**Flood Control Project Maintenance
Levee Inspections**
LMA District Cover Sheet
Spring 2018 Levee Inspection Results

Reclamation District No. 0501 Ryer Island

Spring 2018 Levee Inspection Results

Levee Inspection Report By Mile - Spring 2018

Photo 1 of 3 : UCIP_SP_2018_44720_73904.jpg

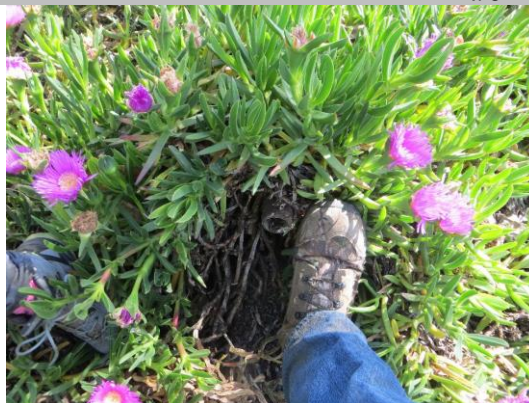
LM Start	4.57	Rating **	M	Issue No.	993	
LM End	4.57	Issue Type +	En	Location *		
Category	Supplemental			GPS Latitude/Longitude		
				Start		End
Item	DWR UCIP Field Study			38.194438 °		38.194438 °
				-121.623063 °		-121.623063 °
DWR ID						
Comment Code						
Inspector Comment						
FS_ID:44720 DS_ID:21103 EP_NO: N/A Repair Type: Non-Urgent Crossing Status: Indicator Found UCIP Comments: Need to verify type of abandonment and if needed abandon it properly. FIELD_STRUCT_DESC: *ABANDONED* 12-inch pipe of an unknown material or purpose through the levee, 3 feet below the crown. 1.5-inch electrical conduit is visible on the landside (LS) slope, 3 feet below the crown, good indicator for the pipe crossing. [Additional Reference(s): USACE Sacramento O&M Manual 105, April 1959, (HLM 4.9)]. FS Date: 4/21/2015

Pipe visible on LS slope. Succulants mound up over pipe.

Photo 1 of 1 : SP_2018_RD0501_169_1_20180305_00001.jpg

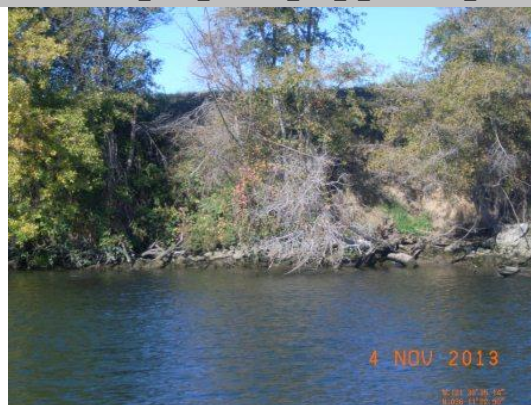
LM Start	5.77	Rating **	M	Issue No.	1
LM End	5.84	Issue Type +	Ma	Location *	WS
Category	Supplemental			GPS Latitude/Longitude	
				Start	End
Item	2015 USACE Erosion Survey, DRAFT			38.190001 °	38.189311 °
				-121.643160 °	-121.643917 °
DWR ID	DWR_RD0501_01_f_2017_1				
Comment Code					
Inspector Comment					
2008 - Overstepped levee section with multiple small pockets of erosion 10 - 20 ft wide. 2013 - Site has fresh erosion and taller vertical sections. 2015: No observed changes. [2015 Site ID: STM_15-7_R]

Photo 1 of 3 : UCIP_SP_2018_44865_58975.jpg

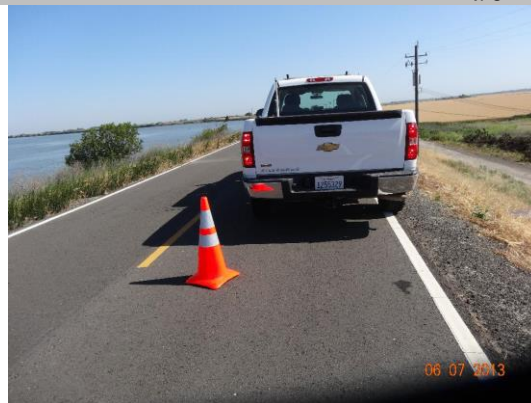
Comment Code					
Inspector Comment					
FS_ID:44865 DS_ID:21038 EP_NO: 2817 Repair Type: Non-Urgent Crossing Status: Found UCIP Comments: Dense vegetation limits the inspector's visibility to identify signs of pipe failure (leaks) through the slope. Recommend removing vegetation along pipe alignment to conduct proper inspection of structure and appurtenances. Scour hole located on waterward side. FIELD_STRUCT_DESC: 20-inch steel drainage discharge pipe sleeved through a 24-inch steel pipe through the levee, 9 feet below the crown. Flap gate on the waterside (WS) end. Cutoff wall around the pipe at each shoulder. Pipe exposed along both slopes. Rock revetment on the WS slope. Berm on the WS is over 20 feet. (Plans to install a drainage pipe through the levee authorized under Permit No. 2817, 1958 - Reclamation District No. 501 [RD0501])). [Additional Reference(s): DWR Levee Log, 2005]. FS Date: 6/7/2013

Photo 1 of 3 : UCIP_SP_2018_46768_30382.jpg

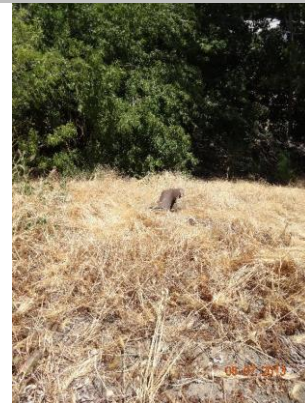
Comment Code					
Inspector Comment					
FS_ID:46768 DS_ID:21049 EP_NO: 1557 Repair Type: Non-Urgent Crossing Status: Found UCIP Comments: Crossing appears abandoned--wooden platform structure appears to be abandoned on waterward side. Small hole underneath pipe on landward side--unable to determine cause (rodent/pipe leak) Need to find owner of crossing to determine status. Recommend removing vegetation along pipe alignment to conduct proper inspection of structure and appurtenances. FIELD_STRUCT_DESC: *ABANDONED* 6-inch irrigation discharge pipe of an unknown material through the levee, 2.5 feet below the crown. Pump in a pump house on the waterside (WS) slope. (Plans for the construction of two irrigation pumping plants, about 500 feet apart, and 6-inch discharge pipes through the levee authorized under Permit No. 1557, 1951 - Poultry Producers of Central California). [Additional Reference(s): DWR Levee Log, 2005. USACE Sacramento O&M Manual 105, April 1959, (HLM 3.9)]. FS Date: 6/7/2013

View of landward side showing a small section of pipe exposed.

Photo 3 of 3 : UCIP_SP_2018_46834_33467.jpg

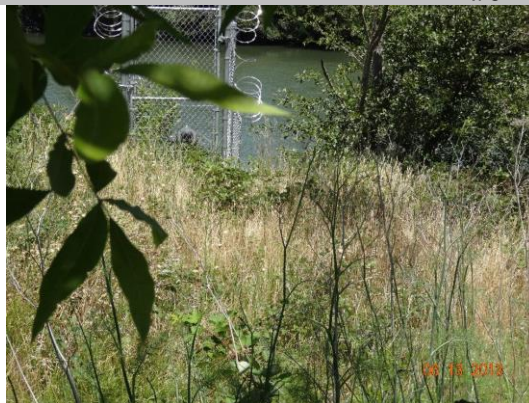
Comment Code						
Inspector Comment						
FS_ID:46834 DS_ID:21061 EP_NO: N/A Repair Type: Non-Urgent Crossing Status: Found UCIP Comments: 11/19/2015 DWR Inspector (H. Phillips) coordinated with LMA superintendent and the owner for this crossing is Walter Koeing, APN No. 042220040. According to LMA superintendent owner installed filter system with fence on landward side and fence around pump in 2012. Pipe not replaced in 2012, this pipe would be a good candidate for internal inspection since the installation date for this crossing was recorded as 1946.06/13/2013 Conduit visible on landward side; new gate on WS toe; filtration system with security fence; Pipe has been upgraded--need permit authorizing work and owner. Dense vegetation limits the inspector's visibility to identify signs of pipe failure (leaks) along the waterward slope. Recommend removing vegetation along pipe alignment to conduct proper inspection of structure and appurtenances. FIELD_STRUCT_DESC: 8-inch steel irrigation discharge pipe through the levee, 3.7 feet below the crown. Siphon breaker and service pole on the landside (LS) slope. 2-inch electrical conduit of an unknown material runs parallel to the 8-inch steel pipe. Pump in a pump house on the waterside (WS) slope. [Additional Reference(s): DWR Levee Log, 2005. USACE Sacramento O&M Manual 105, April 1959, (HLM 8.0)]. FS Date: 6/13/2013

Photo 1 of 3 : UCIP_SP_2018_50025_59039.jpg

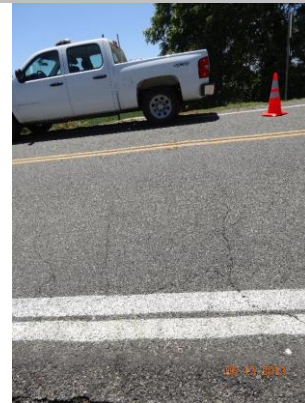
Comment Code						
Inspector Comment						
FS_ID:50025 DS_ID:21063 EP_NO: 11812 Repair Type: Non-Urgent Crossing Status: Found UCIP Comments: 8/22/2016 Crossing has been downgraded from Urgent to Non-Urgent no levee damage appears to be present along pipe alignment. There appears to be an erosion site adjacent to this crossing. Need to coordinate with DWR Inspectors. (DWR UCIP - omagana)6/07/2013 Open cut section of levee on LS slope 8 foot wide--repair work needed. Abandoned pump on waterward berm. Dense vegetation--Recommend removing vegetation along pipe alignment to conduct proper inspection of structure and appurtenances on waterward side. (DWR UCIP - omagana) FIELD_STRUCT_DESC: 14-inch coated steel irrigation discharge pipe and a 1.25-inch electrical conduit of an unknown material through the levee, both 3 feet below the crown. Cutoff wall around the pipe and conduit at the center of the levee. Siphon breaker at the apex of the pipe on the landside (LS) shoulder. Slant pump on the waterside (WS) slope. Discharge structure at the LS toe. Rock revetment on the WS slope. (Plans to replace a 14-inch irrigation pipe through the levee crown and a slant pump on the riverbank authorized under Permit No. 11812, 1976 - Harry H. Rasmussen). [Additional Reference(s): DWR Levee Log, 2005]. FS Date: 8/22/2016

Photo 1 of 3 : UCIP_SP_2018_32546_59047.jpg

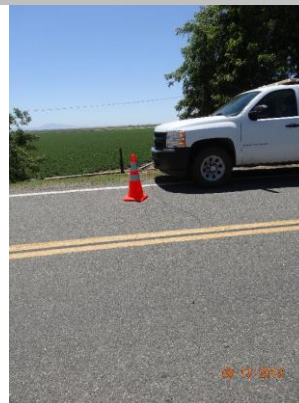
Comment Code						
Inspector Comment						
FS_ID:32546						
DS_ID:21064						
EP_NO: N/A						
Repair Type: Non-Urgent						
Crossing Status: Found						
UCIP Comments: Debris (pipe section) located on waterward berm.						
Dense vegetation limits the inspector's visibility to identify signs of pipe						
failure (leaks) along the waterward slope. Recommend removing						
vegetation along pipe alignment to conduct proper inspection of						
structure and appurtenances.						
FIELD_STRUCT_DESC: 8-inch steel irrigation discharge pipe through						
the levee, 2.7 feet below the crown. Pump in a pump house at the						
landside (LS) toe. [Additional Reference(s): DWR Levee Log, 2005.						
USACE Sacramento O&M Manual 105, April 1959, (HLM 8.2)].						
FS Date: 6/13/2013

Photo 2 of 3 : UCIP_SP_2018_32551_59072.jpg

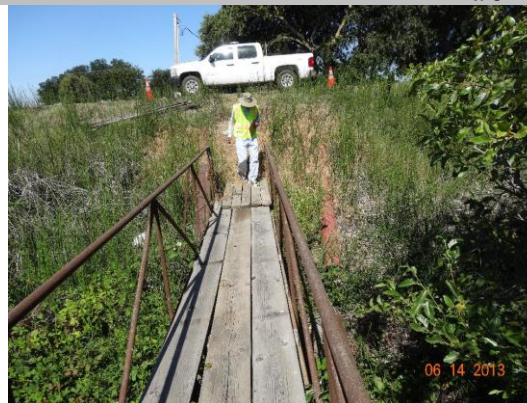
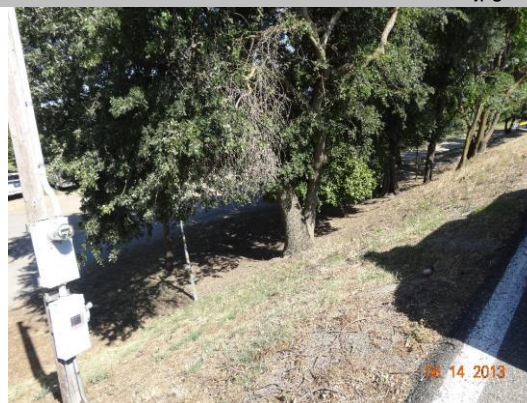
Comment Code						
Inspector Comment						
FS_ID:32551						
DS_ID:21074						
EP_NO: N/A						
Repair Type: Non-Urgent						
Crossing Status: Found						
UCIP Comments: Unable to determine status of crossing. Pipe visible on waterward side--could be the pipe that was supposed to be removed under permit number 13983 (1985). Also present is a 1.5 inch conduit along the 8 inch pipe. Need to coordinate with owner.						
FIELD_STRUCT_DESC: 8-inch steel irrigation discharge pipe through the levee, 6.4 feet below the crown. Pump on a pile structure in the stream. Service pole on the landside (LS) slope. (8-inch pipe should have been removed and replaced with a 12-inch pipe authorized under Permit No. 13983, 1984 - Mrs. John Thomas). [Additional Reference(s): DWR Levee Log, 2005. USACE Sacramento O&M Manual 105, April 1959, (HLM 1.3)].						
FS Date: 6/13/2013

Abandoned pipe to the right of walkway.

Photo 3 of 3 : UCIP_SP_2018_32552_59075.jpg

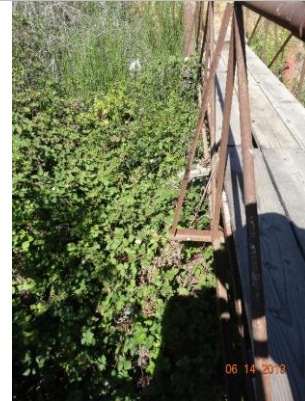
Comment Code					
Inspector Comment					
FS_ID:32552 DS_ID:21095 EP_NO: 13983 Repair Type: Non-Urgent Crossing Status: Found UCIP Comments: Abandoned pipe was to be removed during the installation of new 12-inch pipe crossing. Need to contact pipe owner. Unable to confirm crossing--need additional records for crossing. FIELD_STRUCT_DESC: 12-inch coated steel irrigation discharge pipe through the levee, 5 feet below the crown. Cutoff wall around the pipe at the center of the levee. Siphon breaker at the apex of the pipe on the landside (LS) shoulder. Pump on a pile structure in the stream. Service pole on the LS slope. Pipe connects to a 10-inch steel pipe along the LS slope at the shoulder and similarly to a preexisting 8-inch pipe on the waterside (WS). (8-inch pipe should have been removed and replaced with a 12-inch pipe authorized under Permit No. 13983, 1984 - Mrs. John Thomas). FS Date: 6/13/2013

Photo 3 of 3 : UCIP_SP_2018_32553_59080.jpg

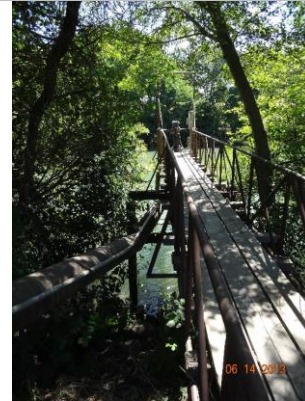
Comment Code						
Inspector Comment						
FS_ID:32553 DS_ID:21077 EP_NO: N/A Repair Type: Non-Urgent Crossing Status: Found UCIP Comments: Dense vegetation limits the inspector's visibility to identify signs of pipe failure (leaks) along the waterward and landward slope. Recommend removing vegetation along pipe alignment to conduct proper inspection of structure and appurtenances. FIELD_STRUCT_DESC: 14-inch steel irrigation discharge pipe through the levee, 8 feet below the crown. 2-inch electrical conduit of an unknown material through the levee, at an unknown depth. Siphon breaker on the landside (LS) slope. Pump on a pile structure in the stream. [Additional Reference(s): DWR Levee Log, 2005. USACE Sacramento O&M Manual 105, April 1959, (HLM 2.0)]. FS Date: 6/13/2013
